How to modify strongback

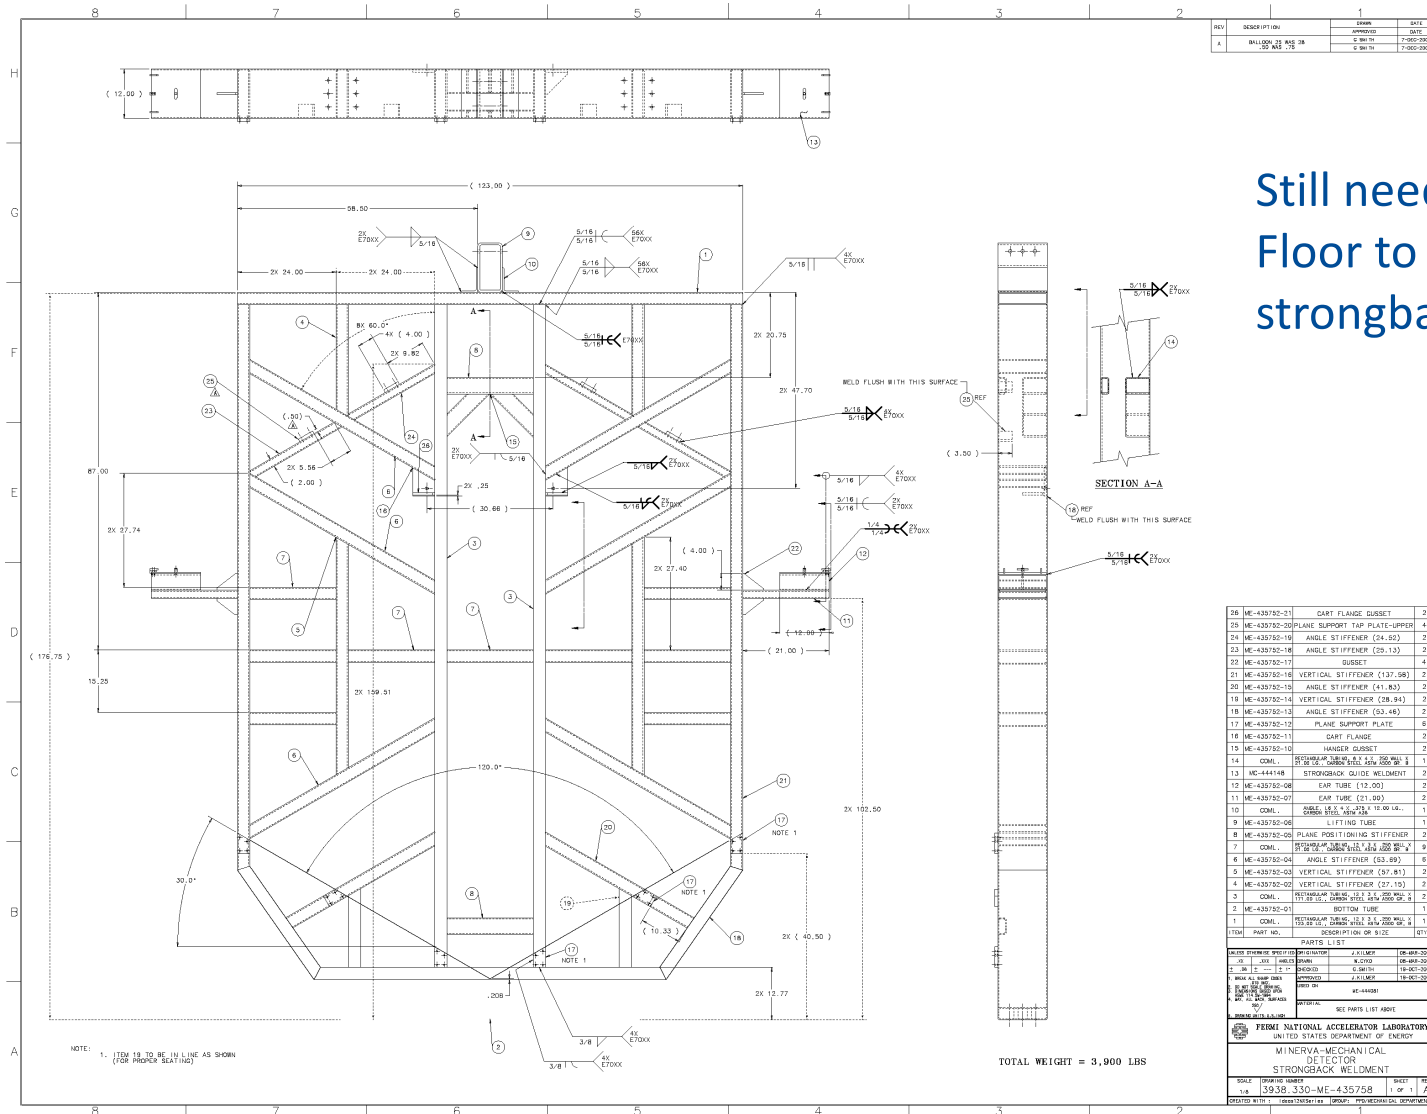
Still need ~2" above
Floor to disengage
strongback
